APPEAL RECOMMENDATION REPORT

Case No.: DIR-2023-4996-TOC-HCA-1A
CEQA No.: ENV-2023-4997-CE
Related Case: DIR-2023-4996-TOC-HCA
Council No.: 10 – Hutt
Plan Area: Wilshire
Plan Overlays: None
Certified NC: P.I.C.O.
Land Use Designation: Medium Residential
Zone: [Q]R3-1-O

PROJECT LOCATION: **1459 South Hi Point Street**

This firm represents Elaine Johnson, who hereby appeals the approval of Tier 3 Base and Additional Incentives at 1459 S. Hi Point Street for a five-story residential development with one level of subterranean parking, 19 dwelling units, 24 parking spaces and 22 bicycle parking spaces ("Project"). As detailed herein, the Project is not eligible for Tier 3 Incentives because it is not within 1,500 feet of a Major Transit Stop. Moreover, the Project does not comply with the "Q" Conditions in Ordinance No. 168,193 because it fails to provide the required open space or street trees. Finally, the Project is not eligible for the Class 32 Categorical Exemption.

SITE PLAN
ROOF PLAN

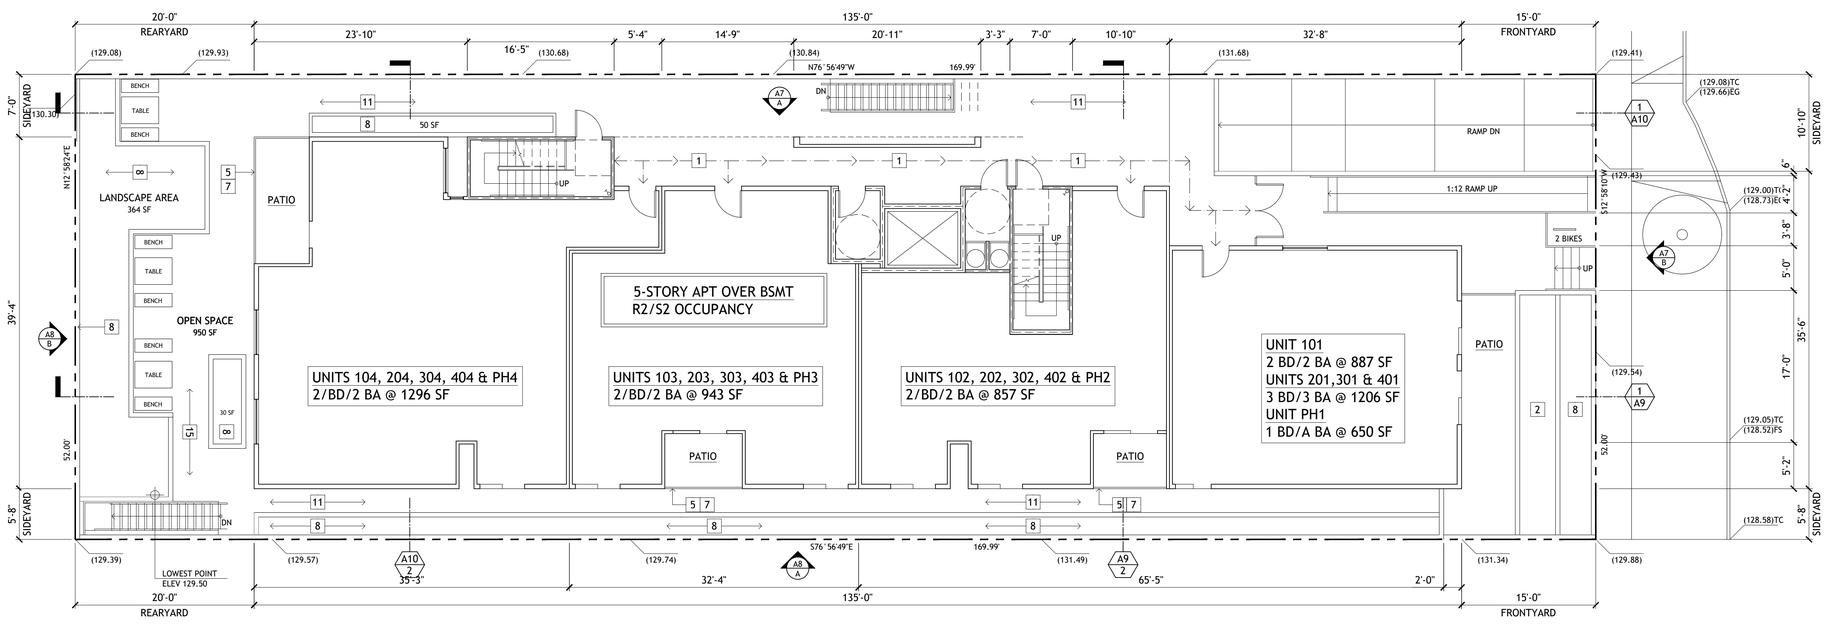
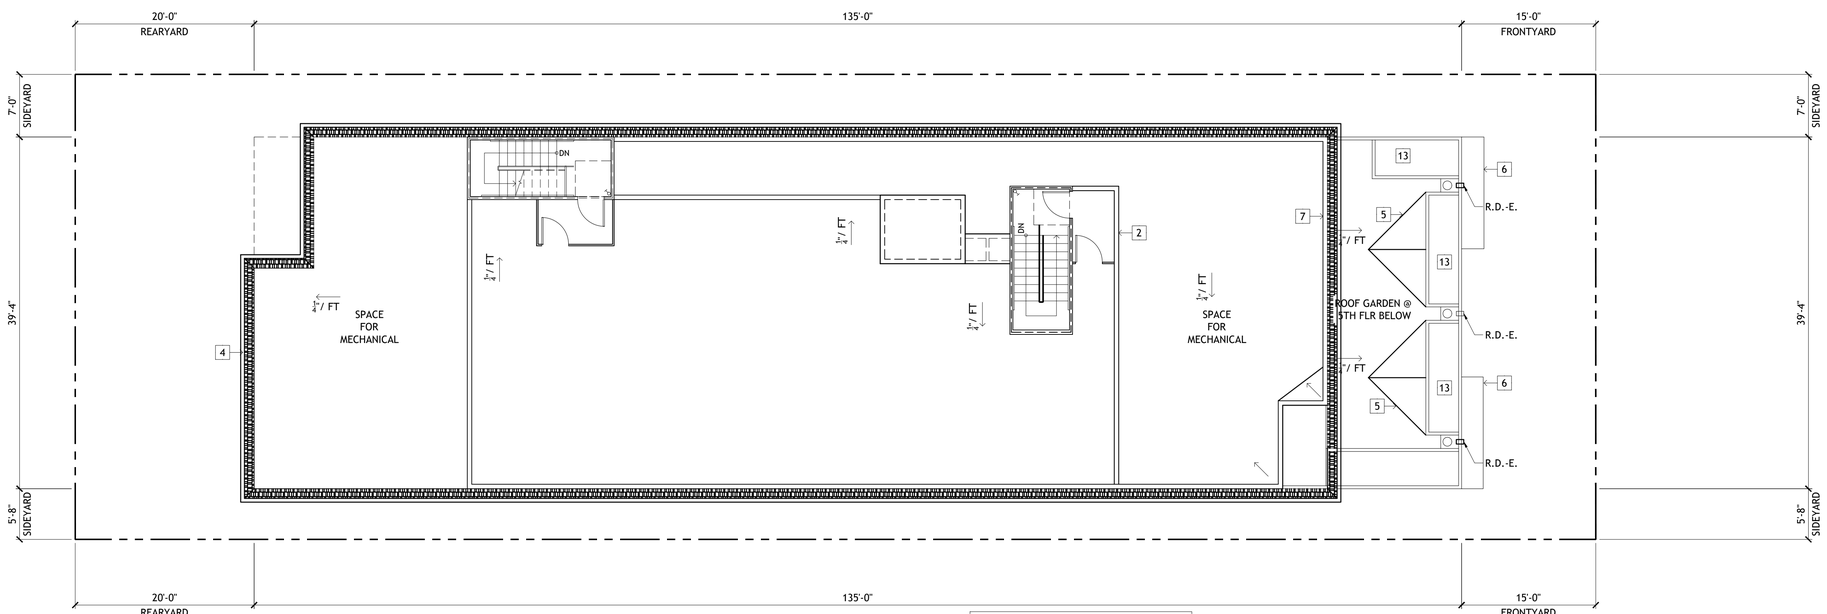
- The "Q" Conditions require that open space be "usable" and that common open space "shall incorporate recreational amenities[.]" The Project Plans depict planters reaching approximately four feet in height in the rear yard for much of its areas, rendering this area unusable—especially considering that the depth of the planters far exceeds an ordinary arms' length, putting it out of reach and making it literally inaccessible and unusable to its purported beneficiaries. Because these planters cannot constitute usable open space, the entire rear yard fails to meet the 20-foot

- The 592 square-foot "roof garden" does not qualify as open space under the "Q" Conditions for several reasons. First, it is located on a rooftop and therefore cannot qualify as open space under the "Q" Conditions which provide that "rooftops shall not be included as open space." Second, the width of the "roof garden" is less than 15 feet measured east to west because the 15-foot measurement on the plans includes the roof perimeter wall, which will necessarily not be usable as open space. Third, the average width of the "roof garden" is less than 20 feet after accounting for planters and walls which render large portions of the area unusable for open space purposes.

- The "Q" Conditions require that common open space shall provide one 24-inch box tree per three dwelling units, and that those trees shall be planted within the open space. Here, the Project requires six (6) 24-inch box trees within the common open space because it proposes 19 dwelling units. The Project Plans do not depict any box trees in any of the common open space.

- The "Q" Conditions require that 50 percent of common open space shall be planted with ground cover, requiring at least 712.5 square feet of planted ground cover within the common open space. The Project Plans depict 394 (364 + 30) square feet in the rear yard. To provide the remaining required planted ground cover in the "roof garden," 318 square feet would be required. The Project Plans do not calculate the planted ground cover on the "roof garden," although it appears to be approximately three to five feet deep based on the scale of the drawings, providing a maximum of 150 square feet.

ATTACHMENT F

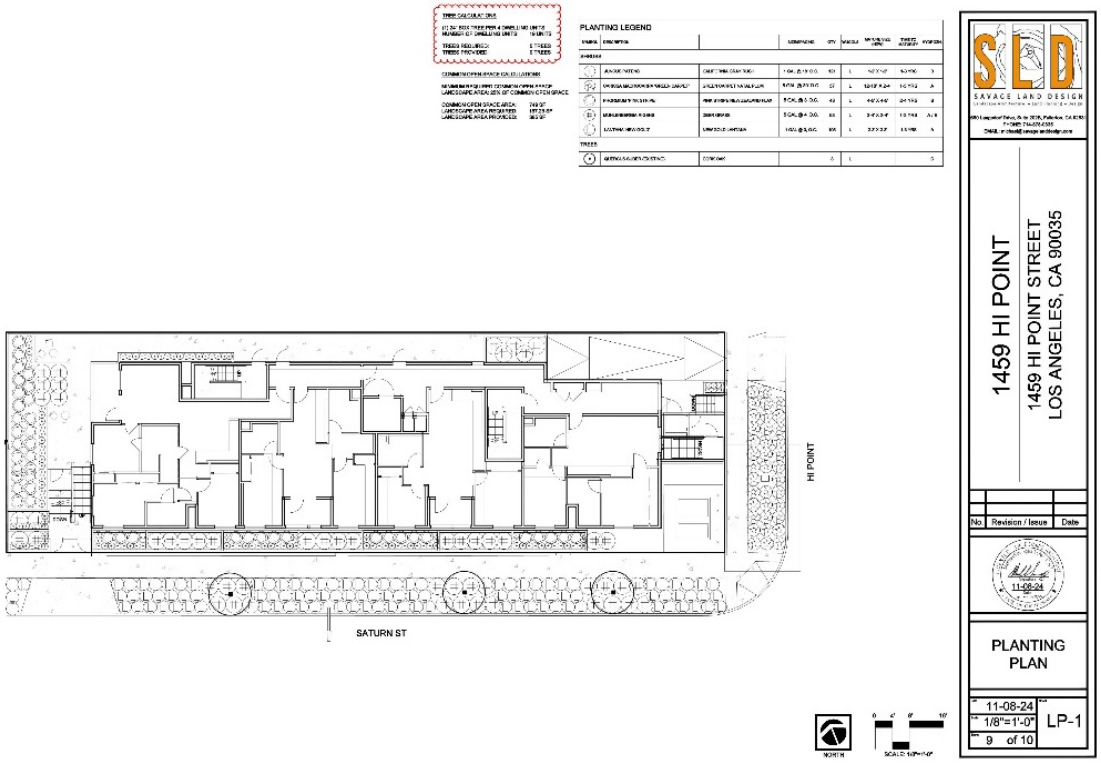
5th floor open space not shown;
architectural drawings omit aspects required for landscape approval
